**Document ID:** IK0400125

**Title: Rear S Cam Tube/ Bracket Part Update**

**Applies To: Prostar, CAT, LoneStar, Durastar, WorkStar, TranStar**

Part update for cast and stamped Rear S Cam Brackets. Revised parts will include an additional gusset for the rear wing bracket and/ or longer gussets and wrap-around weld on the flange side of the tube.

**Figure #1: Cam Tube**

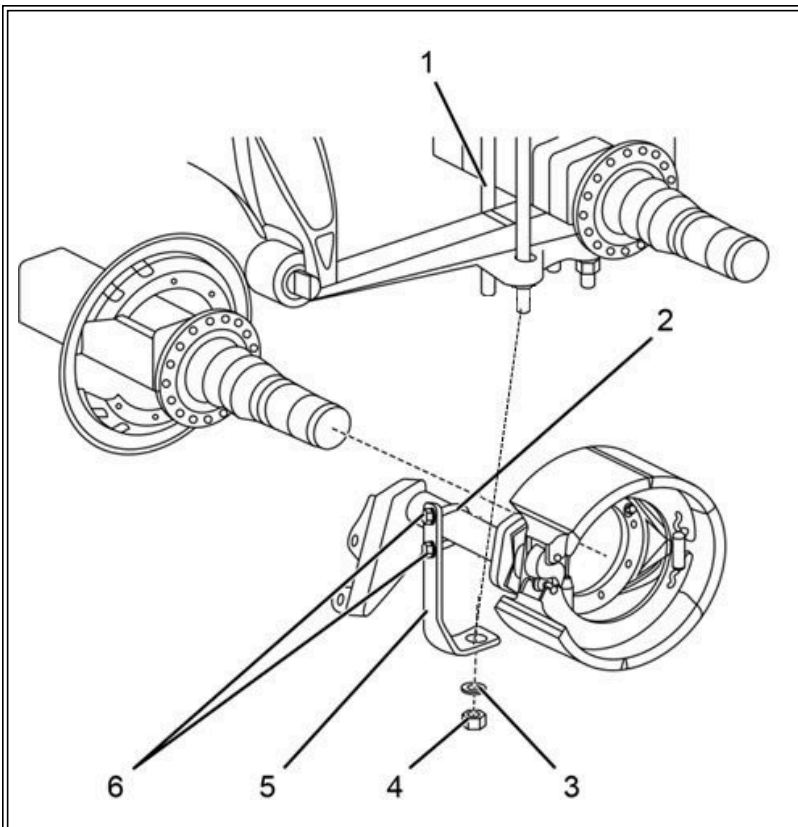
**NOTE: On certain wide base axle applications the new SCAM gusseted bracket will come into contact with the old support brackets. It will be necessary to order and relocate new s-cam Support bracket to the out board side of the U-bolt (Bolt closest the wheel).**

If replacing the passenger side (right side) s-cam bracket you will need a new s-cam support bracket part # 3668032C1  
 If replacing the Driver Side (left side) s-cam bracket you will need a new s-cam support bracket part # 3668033C1

1. Remove and discard the old support bracket
2. Remove Out Board U-Bolt Nut
3. To ensure proper installation of the cam tube support bracket, perform the following:
  - a. Slide the new cam tube support bracket (Figure 1, Item 5) over the outboard U-bolt (Figure 1, Item 1)
  - b. Position the exhaust pipe clamp (Figure 2, Item 2) on the cam tube support bracket (Figure 2, Item 5) and through cam tube support bracket slots with two washers and nuts (Figure 2, Item 1) hand tight.
  - c. Ensure the cam tube support bracket (Figure 2, Item 5) is contacting the cam tube (Figure 2, Item 3) and is sitting flush against the rear U-bolt spring plate (Figure 2, Item 4).
  - d. Using a torque wrench, tighten two nuts (Figure 2, Item 1) to 60 - 72 lb-in (6.8 - 8.1 N•m).
